# Tallawong Station Precinct South

Response to Submissions: Engineering Items

Client: Landcom

17-Oct-2018

Figure 2: Updated Section B

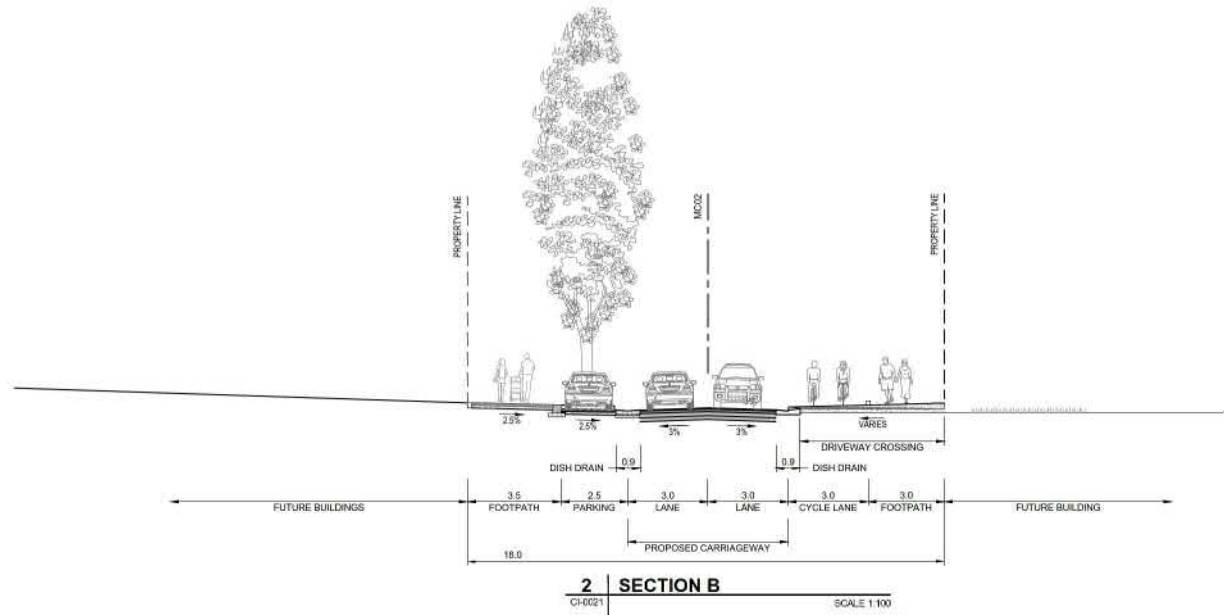
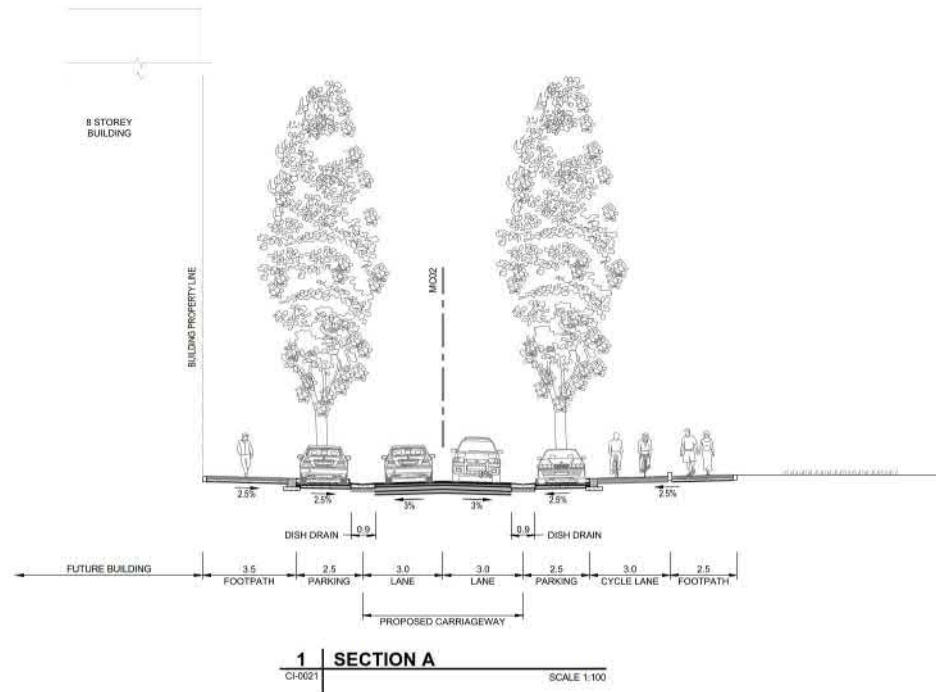
2. *Road verge widths to be minimum 3.5 m*

*All local road footpaths are to be minimum of 1.6 m and this is to include the adjacent SP2 and RE1 area which must be a minimum 3.5 m wide. There is no justification for any reduction in the footpath widths.*

All road verge widths are a minimum 3.5m (when including footpaths) and local road footpaths are a minimum of 1.6 m wide, refer to the following civil drawings:

- 60558549-SHT-CI-0121 – Section B has been amended to remove the parking reference where the cycle lane is located, footpath has also been correctly shown as 3m width;
- 60558549-SHT-CI-0123 – Section F has been amended to show the correct setback distance of 10m; and
- 60558549-SHT-CI-0123 TYPICAL – In consultation with Blacktown City Council (BCC), the footpath width in Section H has been reduced to 3m to allow a 2m landscaped area.

**Figure 5: Proposed Basin Expansion (Plan)**

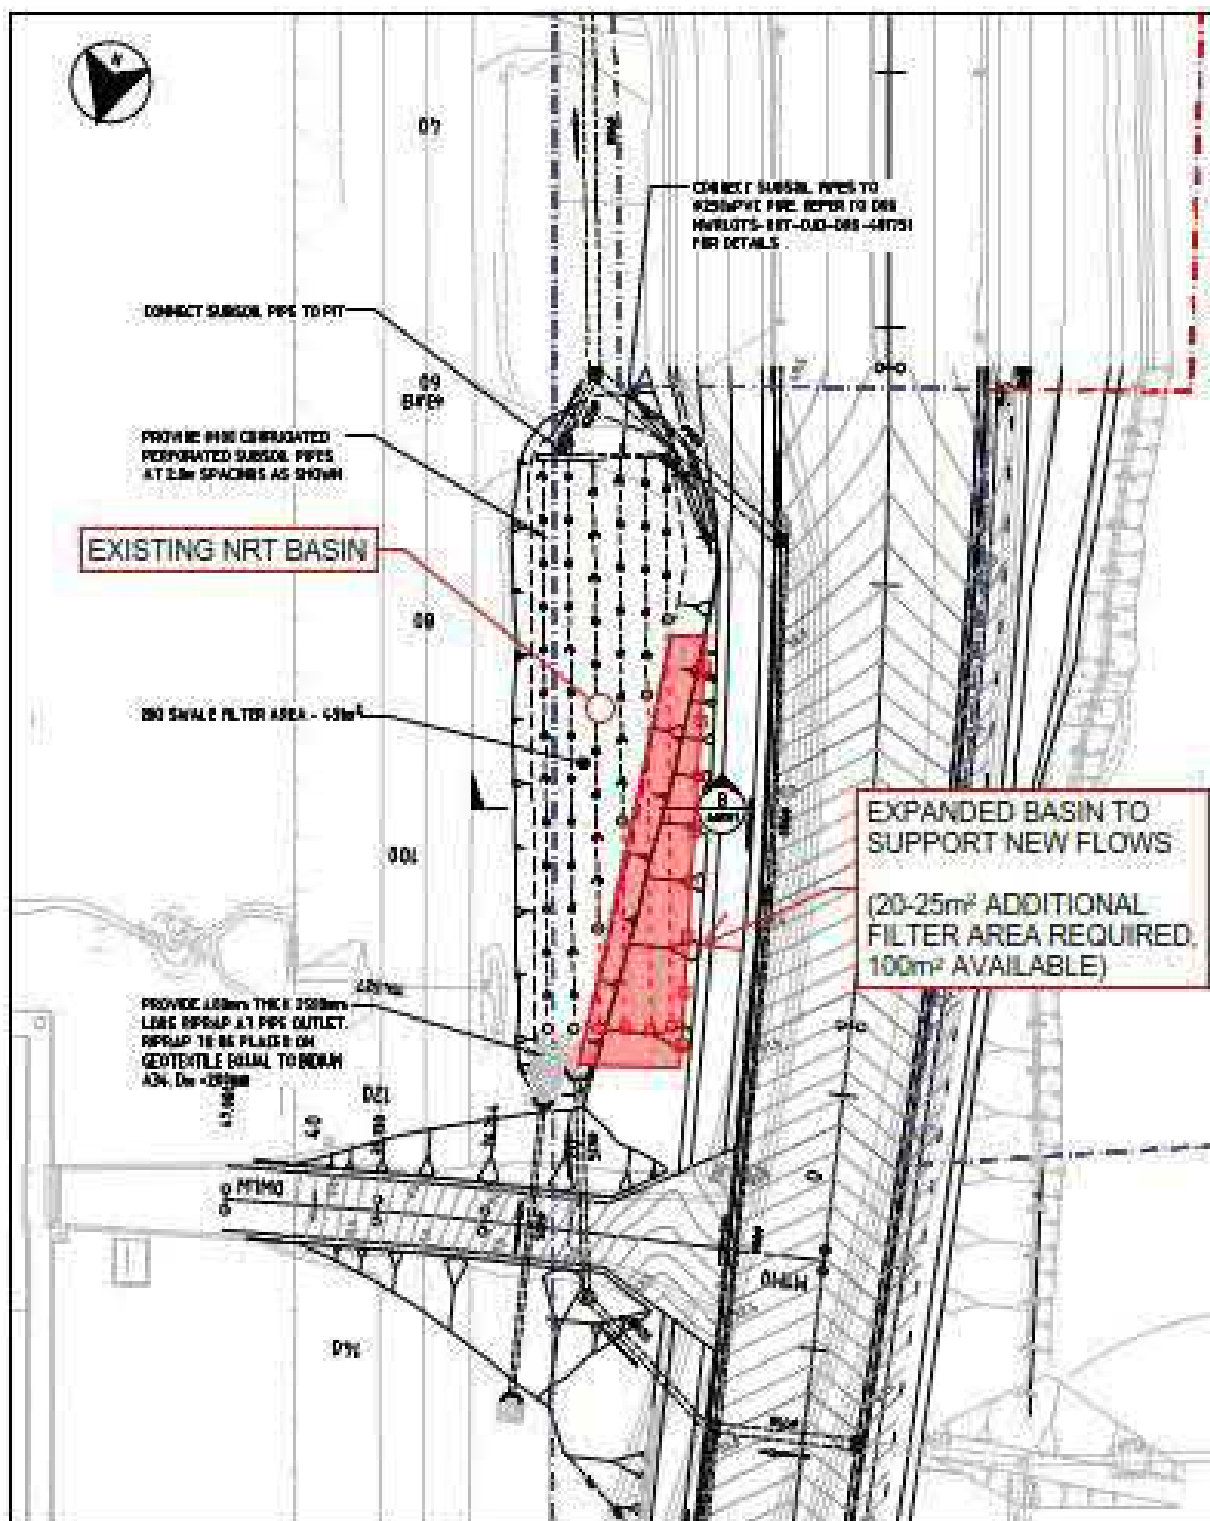
4. *There are substantial contradictions as to the size of the proposed bioretention basin. For the basin, AECOM Drainage Plan Sheet 05 shows a 200 m<sup>2</sup> filter area and 270 mm EDD. Page 20 of the Integrated Water Cycle Management Strategy refers to a 246 m<sup>2</sup> filter area and 300 mm EDD*

- a. *A section through the basin from Cudgegong Road to the access track to show the relationship and levels between the elements. Note our WHS requirements will not accept a 1V:3H batter slope. Maximum is 1V:4H providing it is heavily vegetated and not turfed.*

As detailed in Section 3.4 Design Engineering, the intention is to re-use and expand the current NRT bio-filtration detail. Details of this proposed expansion and filter media are shown below in Figure 5 and Figure 6.

Please note, we have not been able to verify that the size of the biofiltration basin is actually 431 m<sup>2</sup> in the NRT design drawings as reproduced in Figure 5.

Please refer to Figure 5 and Figure 6 above showing a plan and section through the proposed basin extension. It is noted that the existing NRT basin has a 1:3 minimum batter dimension, while a retaining wall is proposed this is only for the north western side of the basin and access is available from the eastern side of the basin.

Figure 7: Biofiltration Street Tree Detail

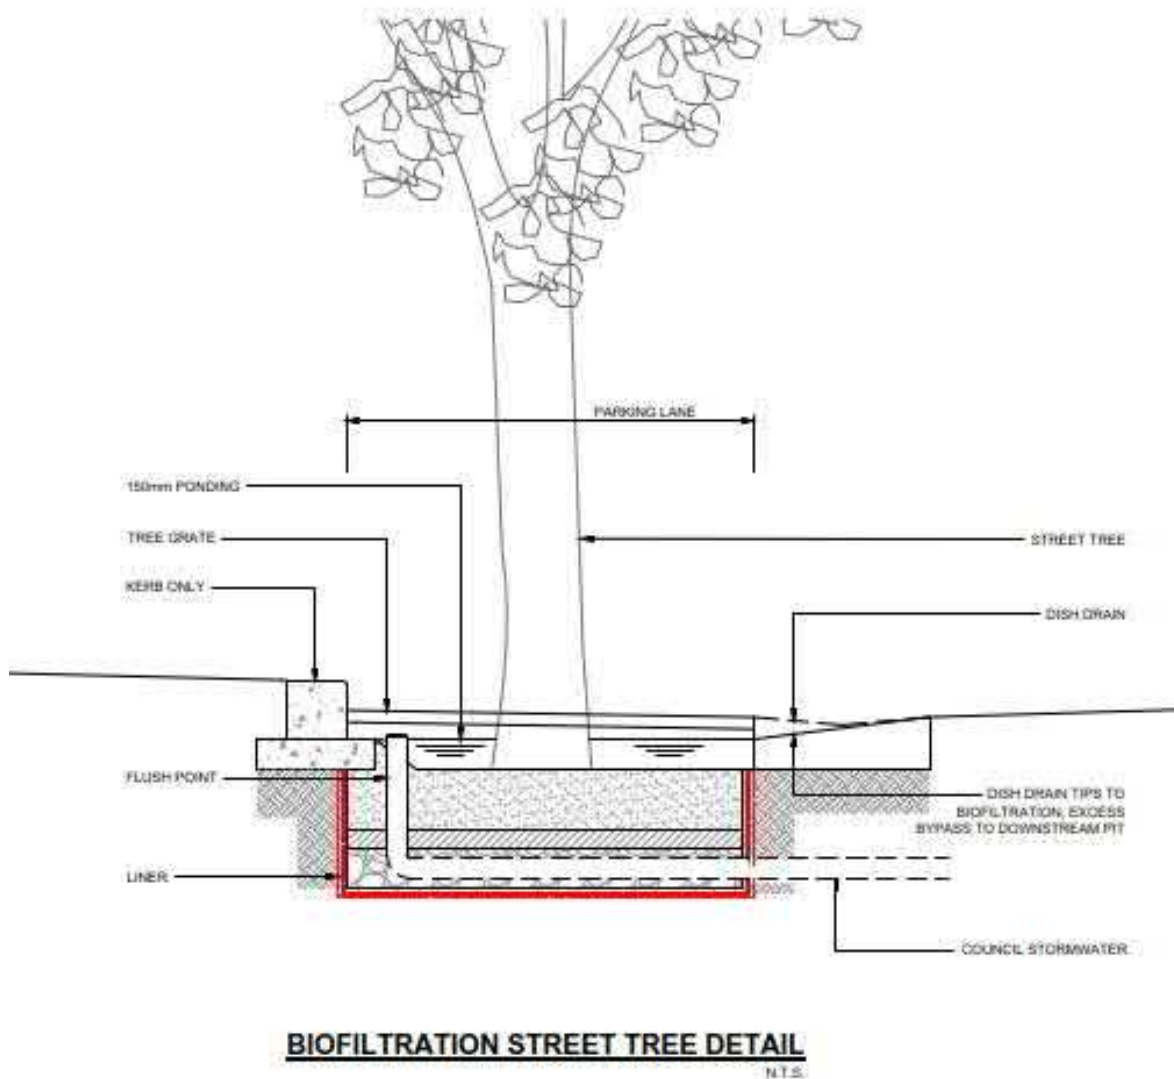
8. Provide a detail for the Biofiltration Street Tree referred to in Section 6.3.3 of the Integrated Water Cycle Management Strategy and design for a minimum of 150 mm of ponding. Allow for 100 mm in the modelling.

This proposed detail is shown below in Figure 7.

Figure 9: Revised Stormwater Strategy Plan

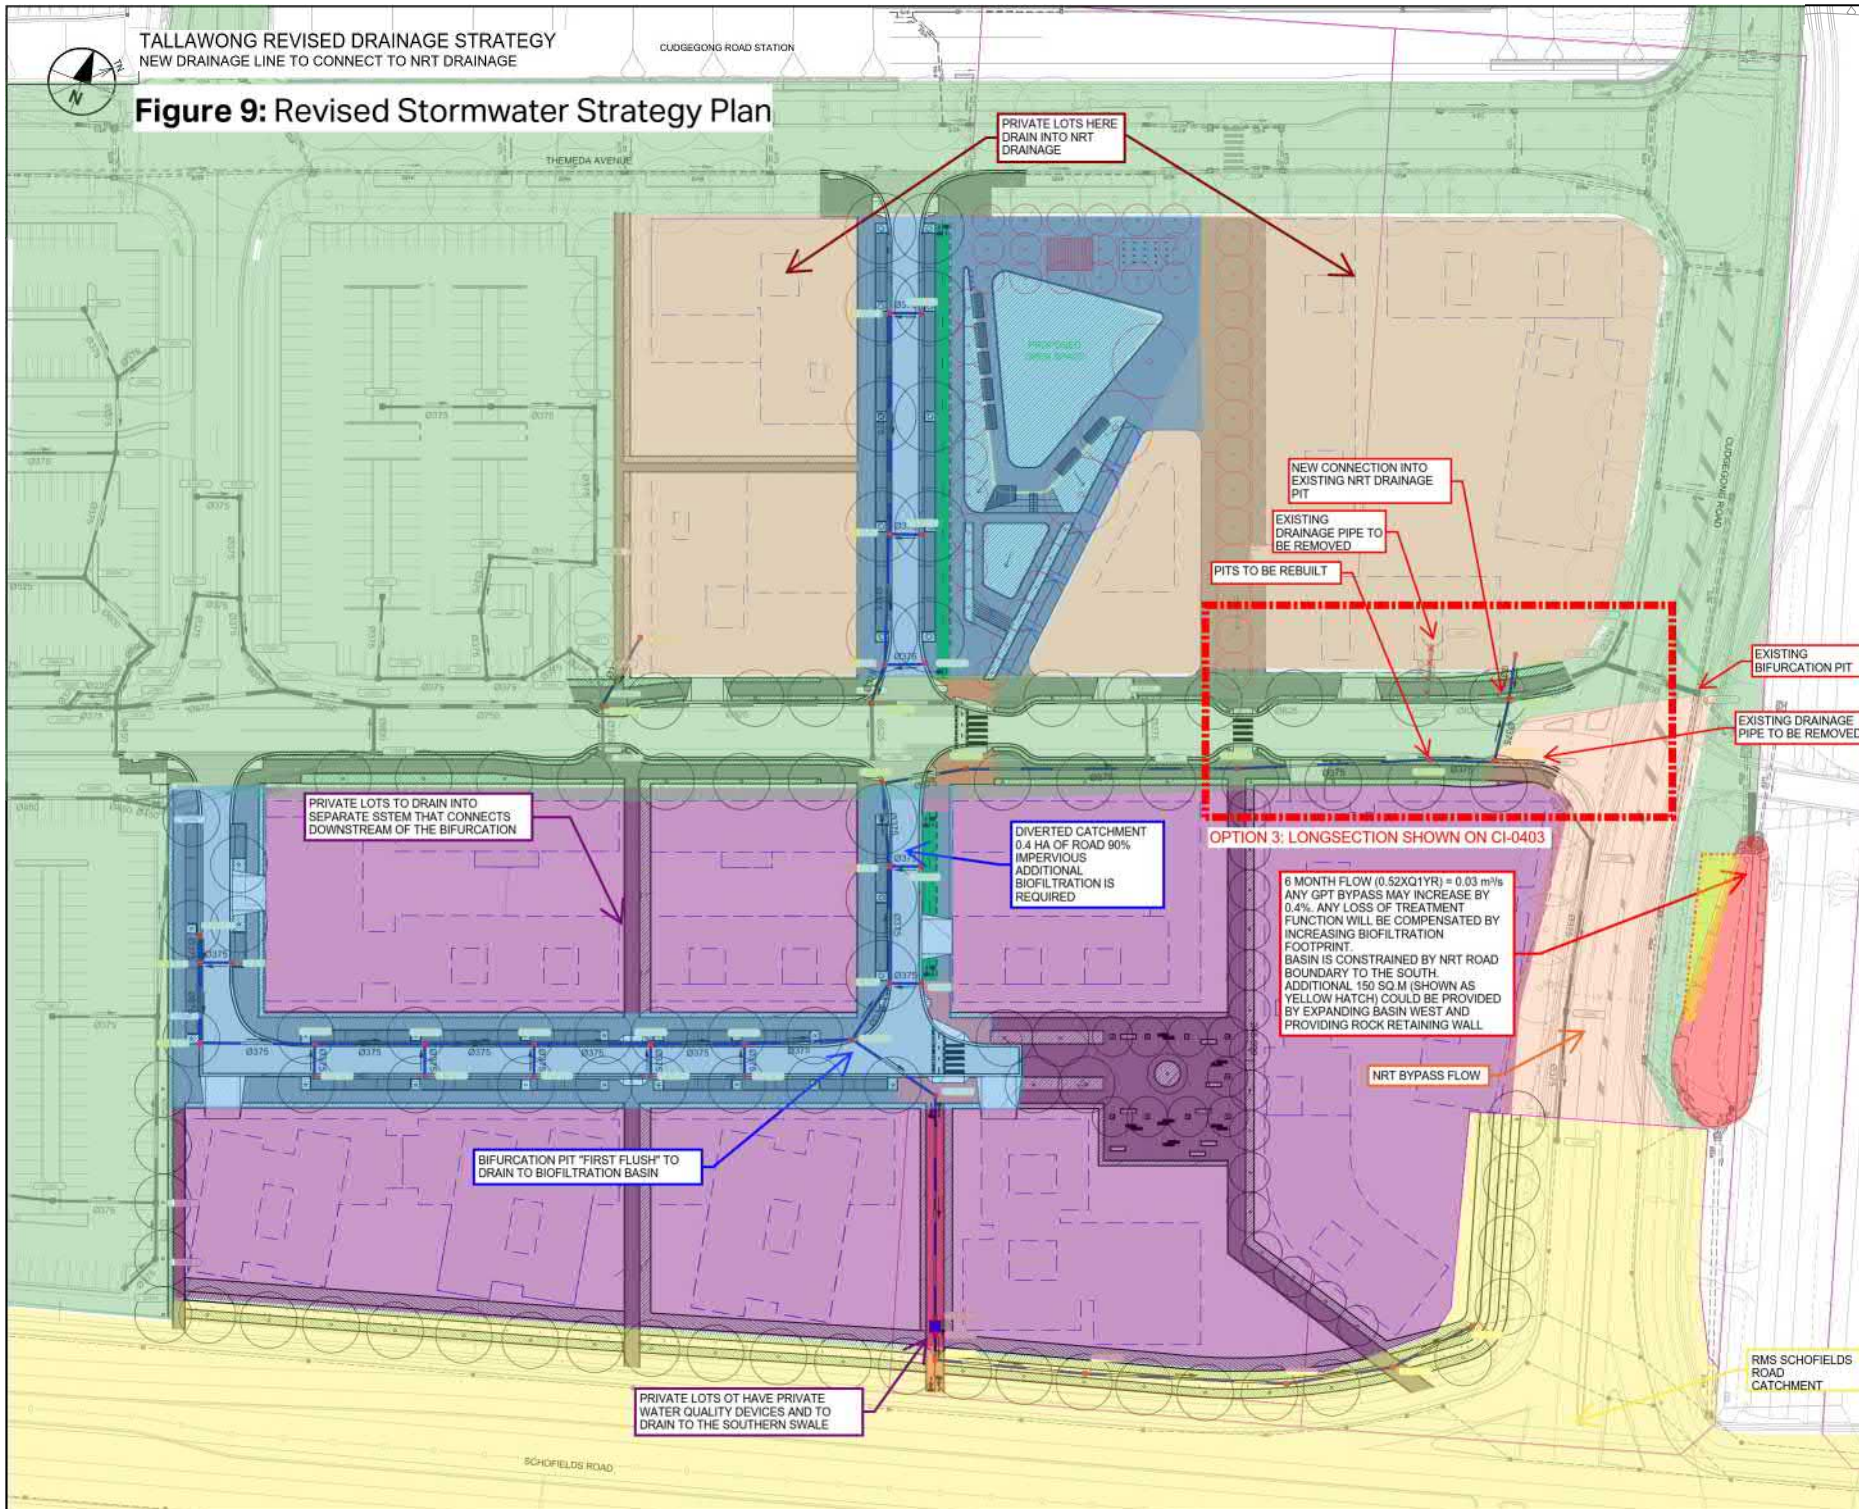
*The SEI calculations are wrong as the pre-developed flows should be calculated with the probabilistic rational method. We require more details of the actual calculations.*

We have reviewed the Stormwater Strategy to explore opportunities to direct runoff of public roads into the NRT bioretention basin. With the removal and replacement of a section of NRT drainage pipes it is possible to divert road stormwater into the bioretention via a connection into the NRT DN900 stormwater pipe.

These options are contained below in Figure 9, Figure 10, Figure 11, Figure 12, Figure 13 and Figure 14. It is noted that these options will avoid the construction of new basin outlets to Second Ponds Creek as the current NRT outlets can be utilised.

Figure 15: Location of Access Driveways

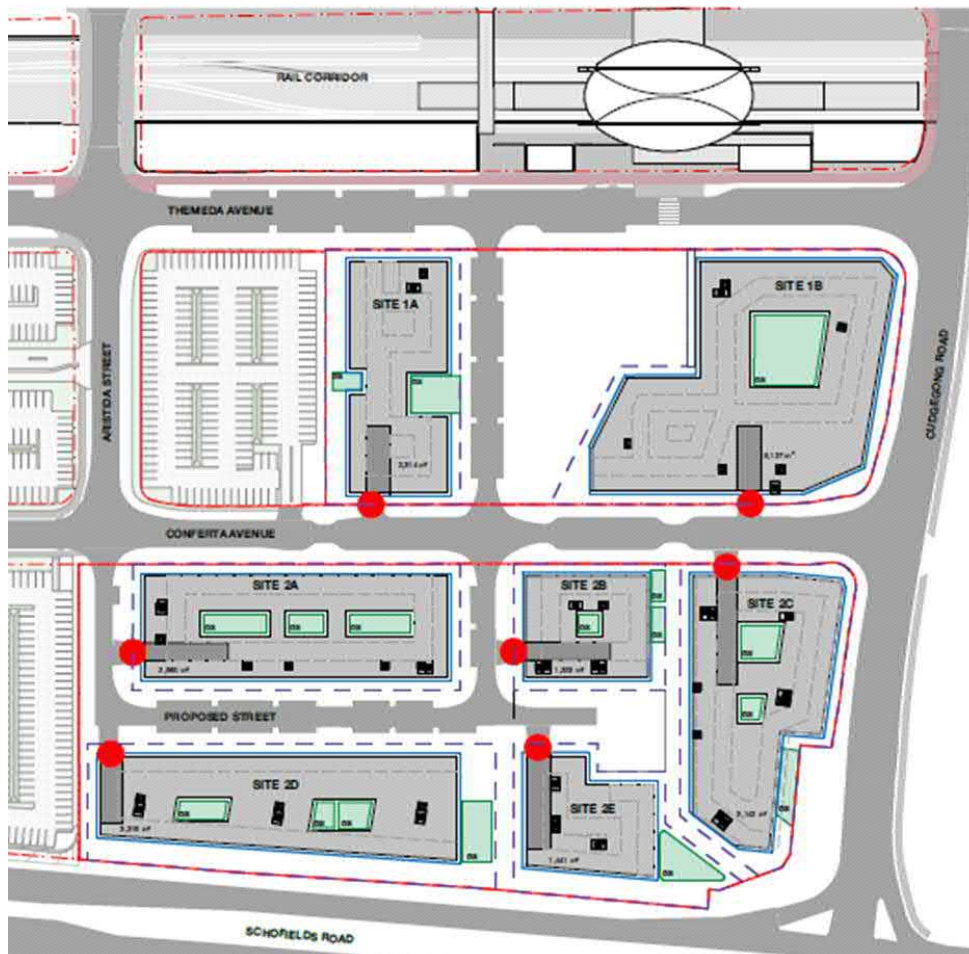
4. *Provision for adequate site distance needs to be made for both pedestrian and vehicular movement at all driveways in accordance with Section 3.2.4 AS 2890.1 and Figure 3.2 of AS 2890.1, to ensure the safety of pedestrians on the footpath system and motor vehicles.*

Site distance calculations for intersections are provided within Section 3.0 of the Civil Design Report (Rev 3, 2018). Site distance checks for the driveways shown in Figure 15 below have been undertaken, this includes the following driveways:

Sight distance checks were completed to ensure that the proposed access arrangements provide a safe environment. Access driveways need to be located such that adequate entering sight distance to traffic on the frontage road as well as sight distance to pedestrians is provided.

#### Figure 18: BCC Growth Centre Precincts Road Widths

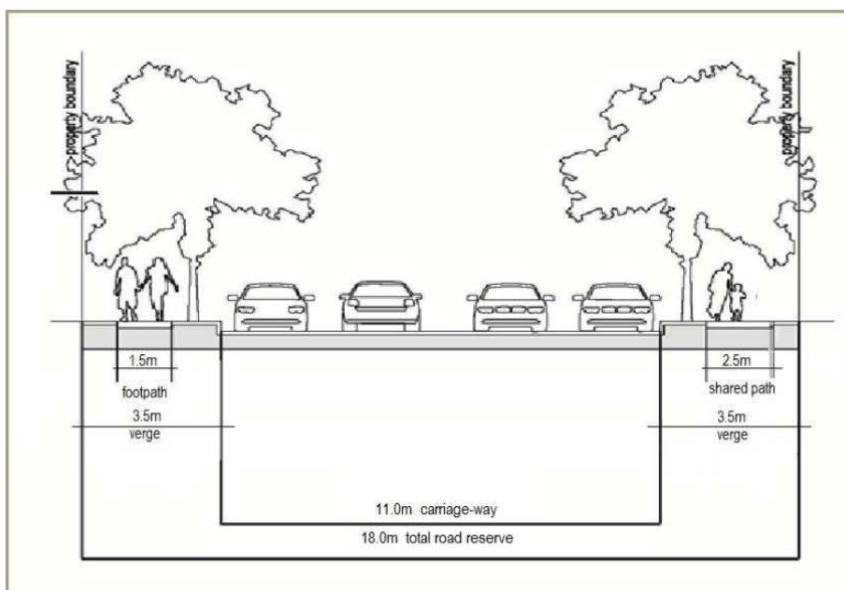
1. *The applicant is to comply with Growth Centre Precincts Development Control Plan, including for road design and widths*

For the North-South Road located adjacent to the designated park, the design widths are based on the Typical Medium-high density local road classification as outlined in Figure 3-14 of the DCP (refer Figure 18 below).
